# Sustainable Wet Processing Plant Ltd

## Structural Inspection Report

**Observation 02:** Change of floor occupancy & mismatch in as-built drawing (Production Building)

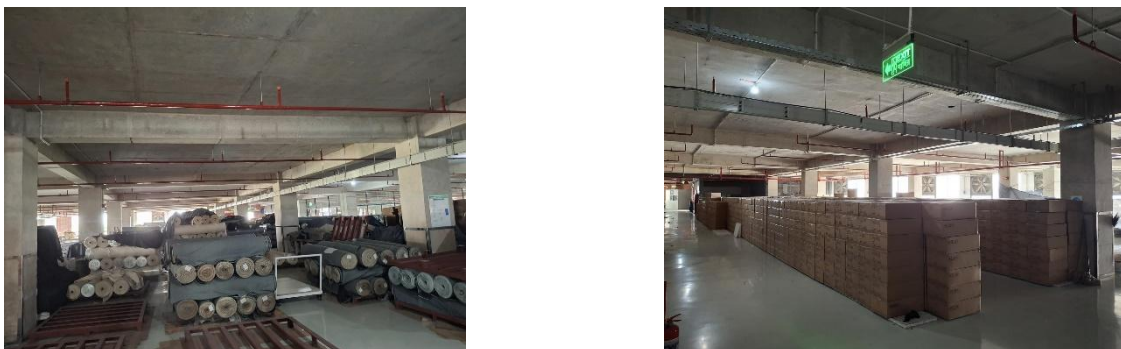
**Description:** During inspection, change of floor occupancy was observed. And floor built ups on 1<sup>st</sup> & 2<sup>nd</sup> floors were not mentioned in the drawings. The building engineer is required to finalize the floor occupancies, update as-built drawings and load plan submit them to RSC.

**Observation-03:** Lack of floor load management (Production Building)

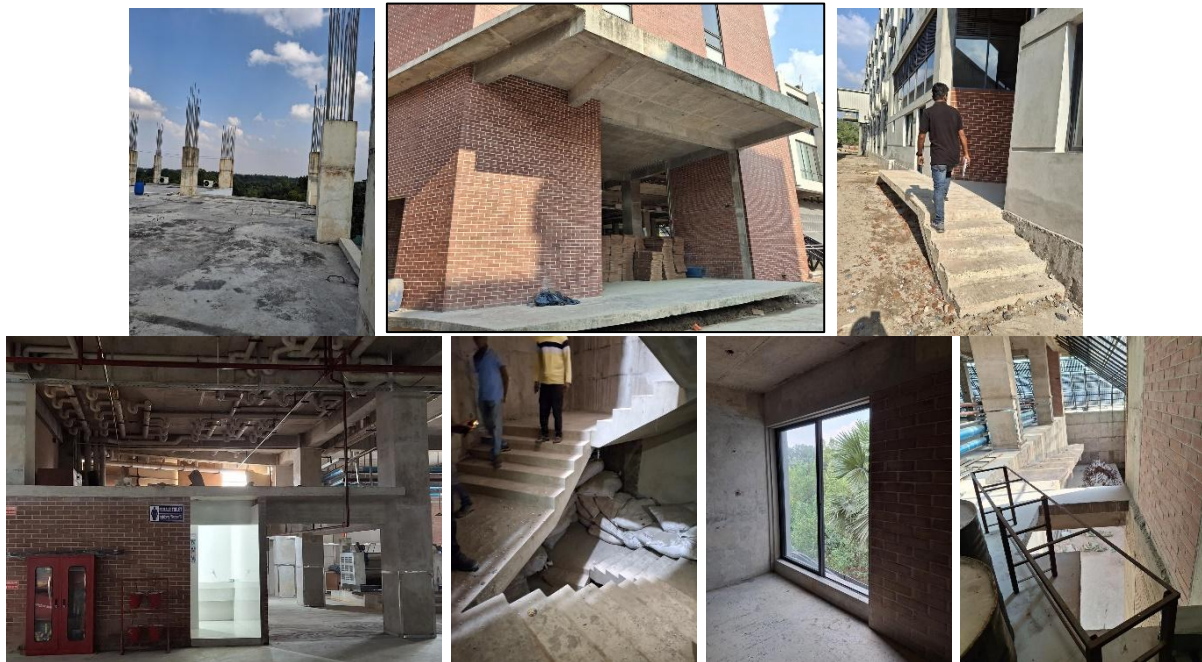
**Description:** Storage height marking was not found onsite. Also, some storage was found in non-dedicated storage areas. The building engineer is required to maintain floor occupancy as per prepared load plan, provide storage height marking and manage floor loading within limits.

**Observation-10:** Lack of floor load management (Utility Building)

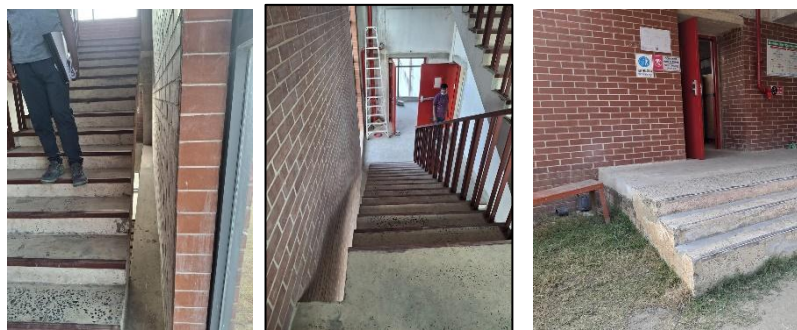
**Description:** Undocumented storage was observed on top two floors. Also, storage height marking was not found onsite. The building engineer is required to maintain floor occupancy as per prepared load plan, provide storage height marking and manage floor loading within limits.

**Observation 14: Mismatch in as-built drawing (Boiler Shed)**

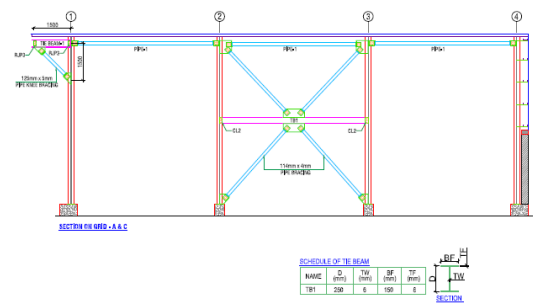
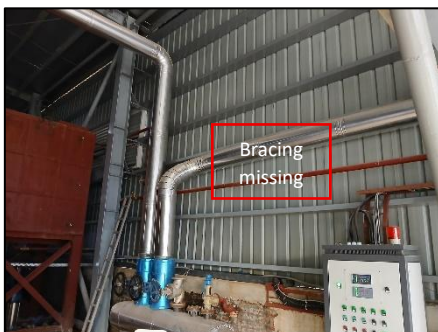
**Description:** Bracing along long direction of the shed was missing onsite. The building engineer is required to update as-built drawings, check the design and submit them to RSC.
